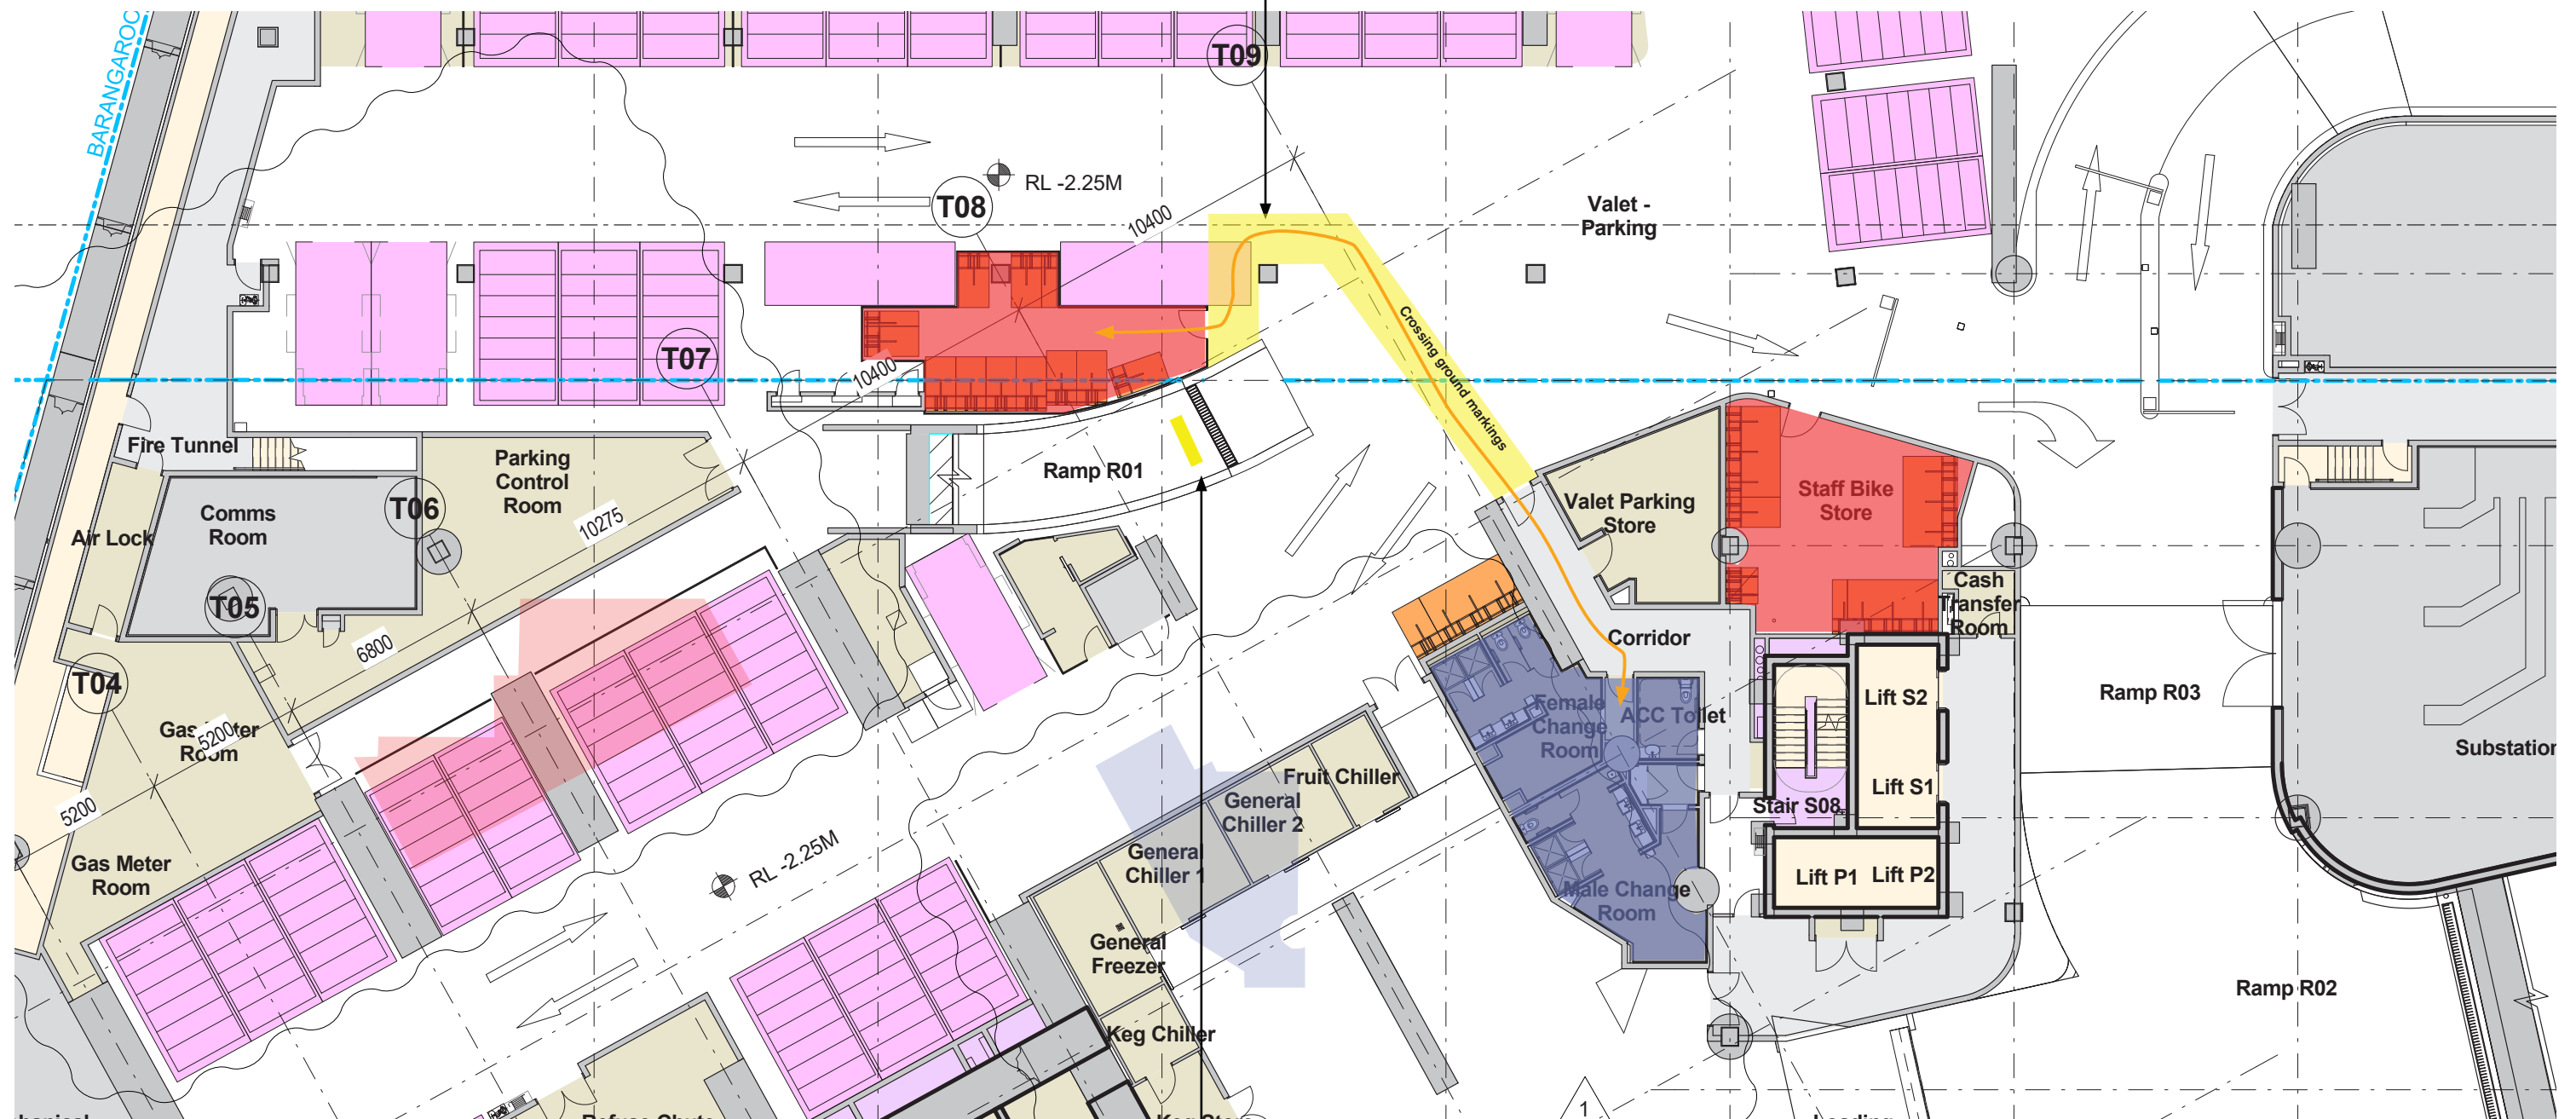
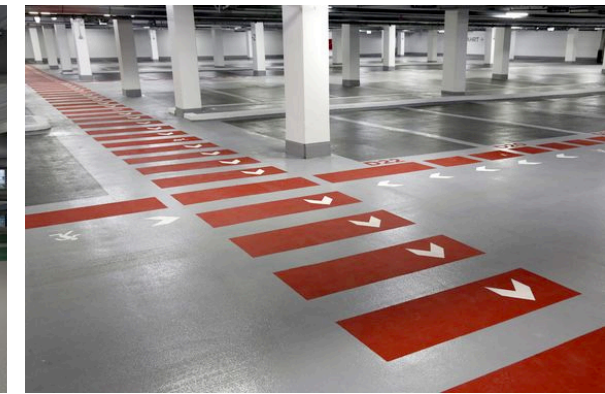
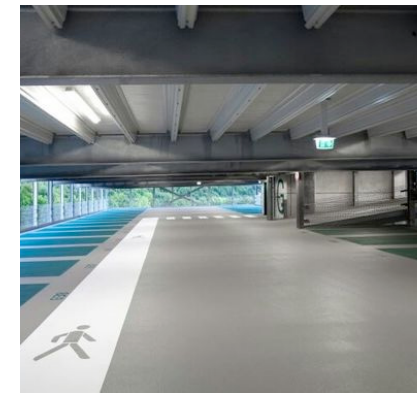
Add ground marking indicating pedestrian circulation zone path in order to group pedestrian movement and draw attention of drivers coming down the valet ramp so it is clear where the pedestrian crossing occurs

Add suspended sign for vehicle drivers moving down the valet ramp instructing to watch for pedestrians at crossing.
